**TECHNICAL MEMORANDUM**

**Re: Phase 3 RI Modification No. 13  
Nevada Environmental Response Trust Site  
Henderson, Nevada  
Ramboll Project No. 1690020169-023**

**RI Phase 3 Modification No. 13  
Incorporation of Additional Analytes into the Soil and  
Groundwater Sampling Programs for Phase 3 RI Modification  
Nos. 8, 11, and 12**

**Phase 3 RI Modification 13 Soil Sampling Locations - PC-205 Pilot Boring and PC-205A/PC-205B Monitoring Wells**  
Nevada Environmental Response Trust Site  
Henderson, Nevada

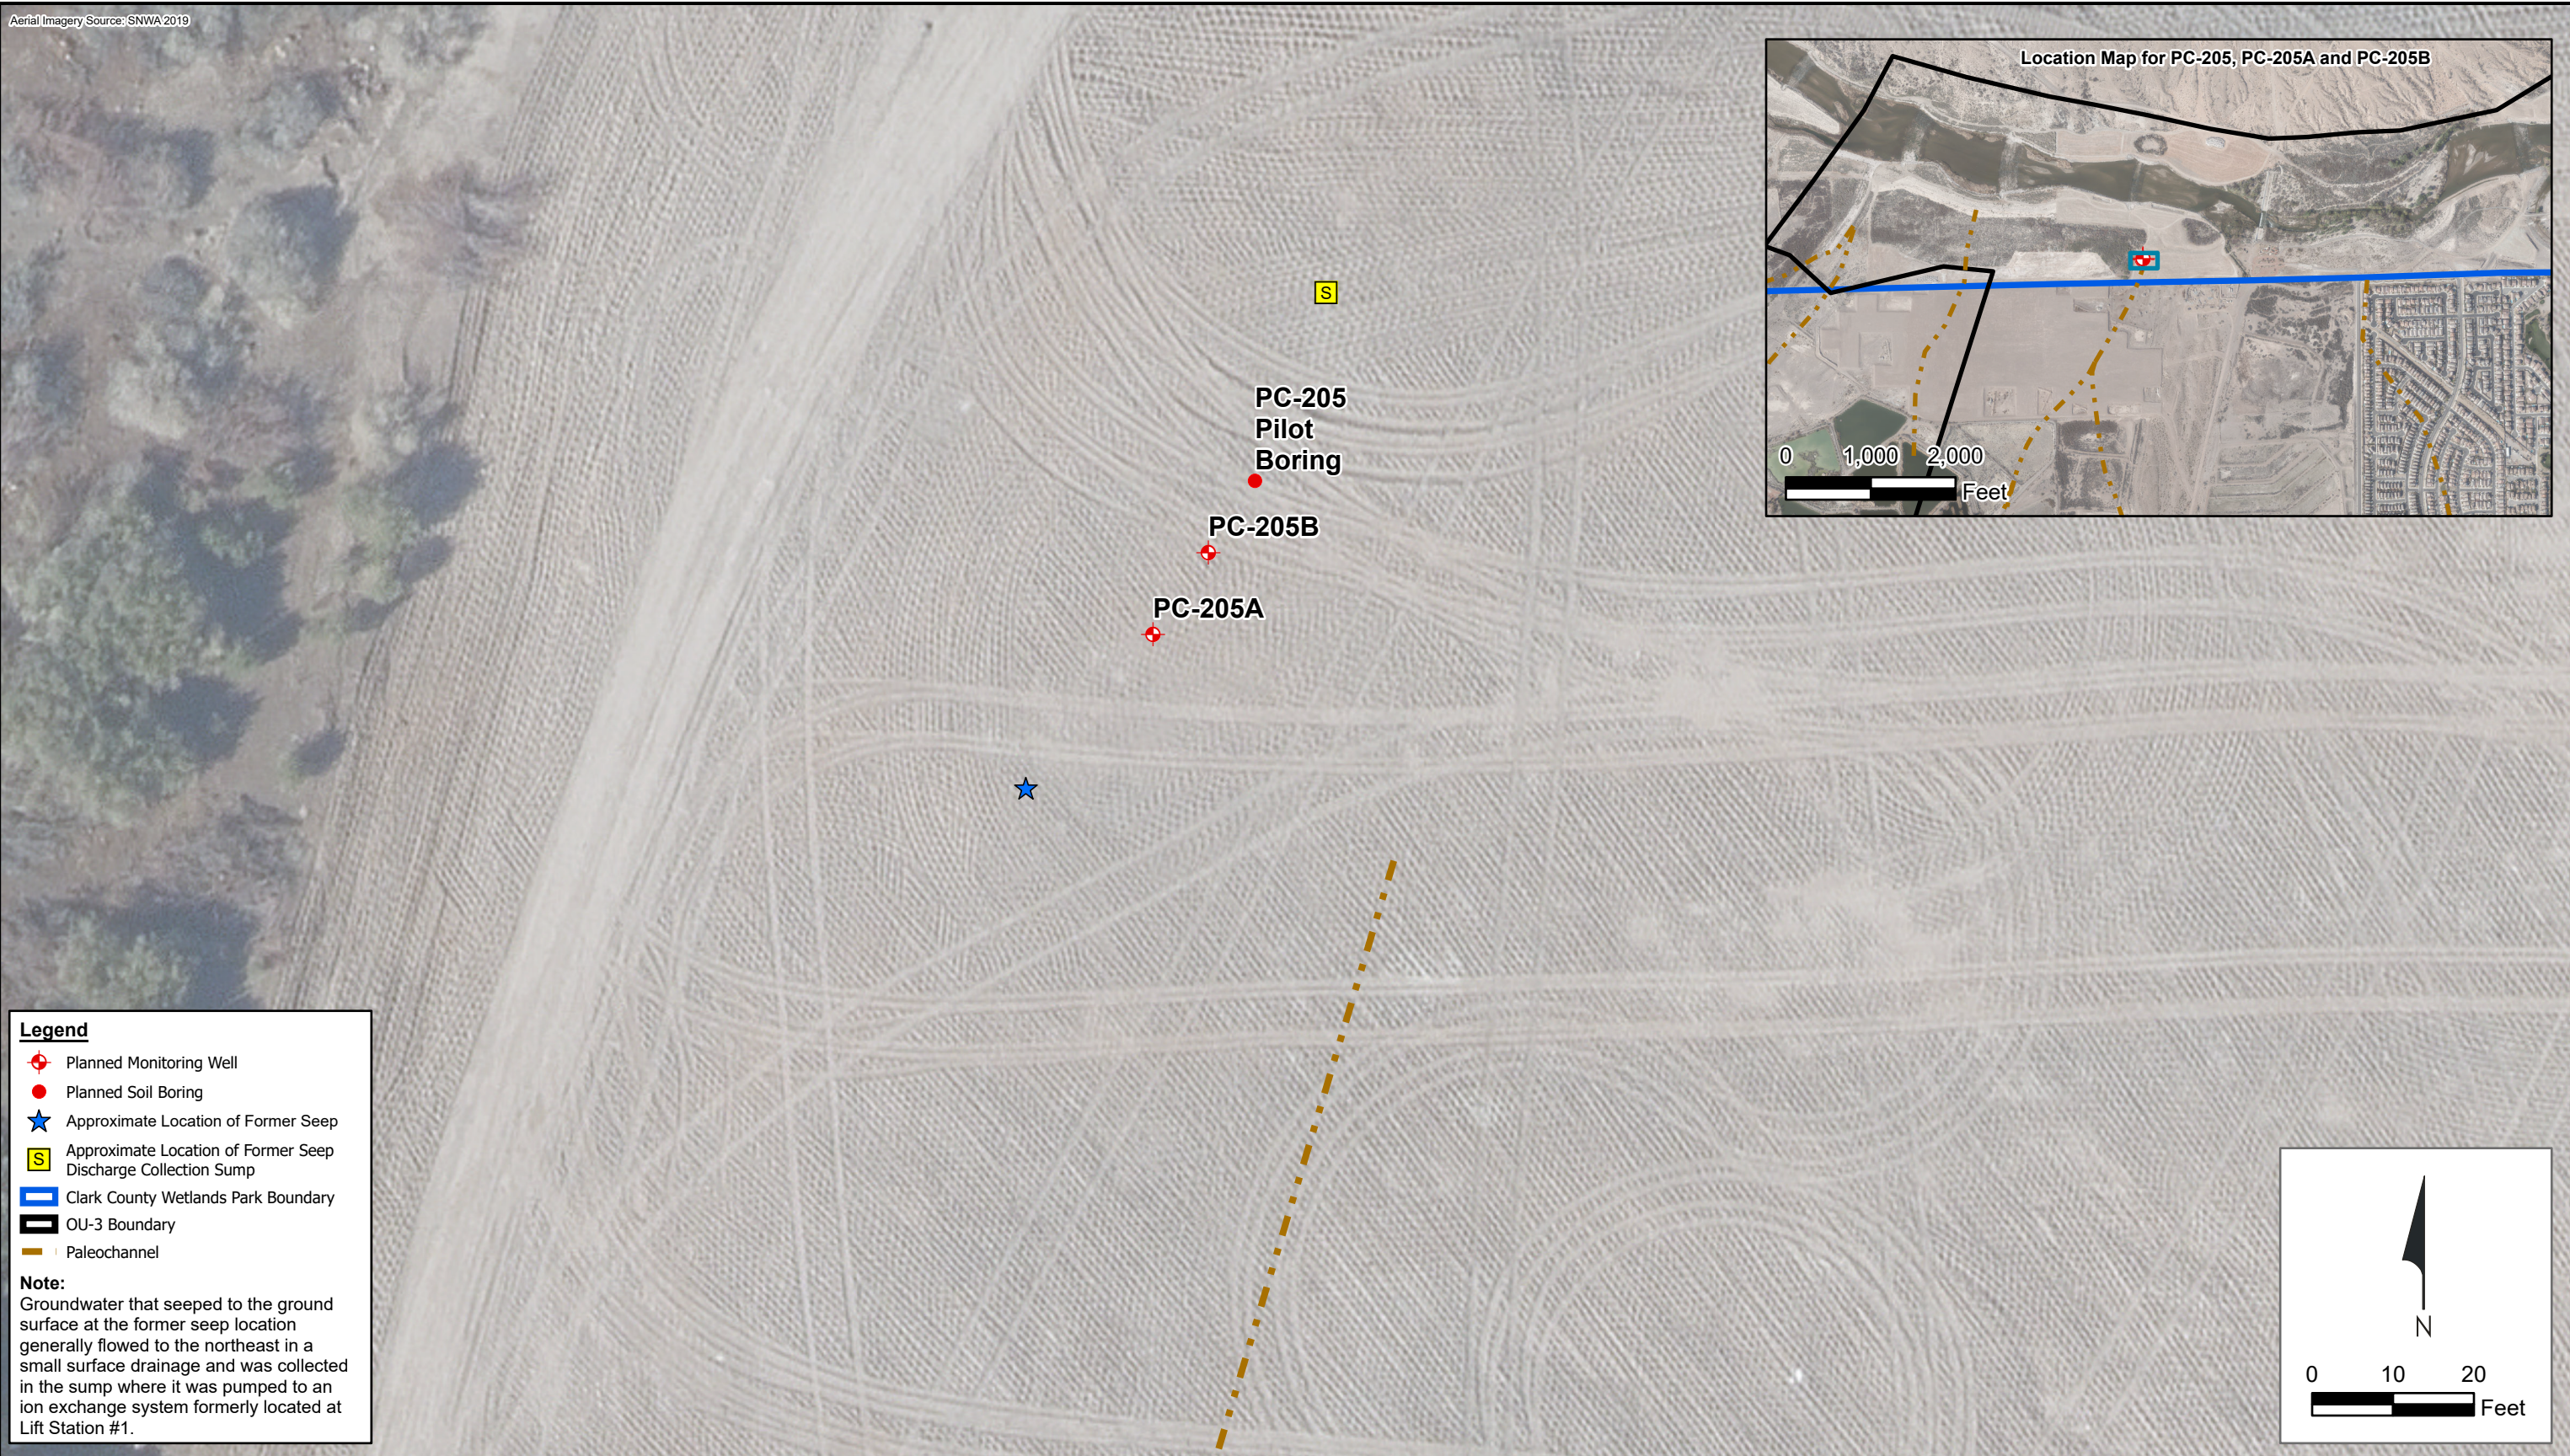
As part of this Modification No. 13, a total of nine additional soil samples will be collected from three depth intervals (0 ft, 5 ft, and 9.5 ft bgs) at one new boring location (the pilot boring PC-205) and the two well locations previously specified in Modification No. 11 (PC-205A and PC-205B; see Figure 1). The locations of these three borings are within the location of the former seep where perchlorate-impacted groundwater was first observed to discharge to the surface in 1999, eventually draining to the Las Vegas Wash. It should be noted that the current ground surface is now approximately 3 feet above the former seep due to regrading that SNWA completed during the construction of the Sunrise Mountain Weir. These soil samples will be analyzed for perchlorate, chlorate, nitrate, nitrite, arsenic, boron, chromium, iron, magnesium, manganese, strontium, vanadium, and VOCs.
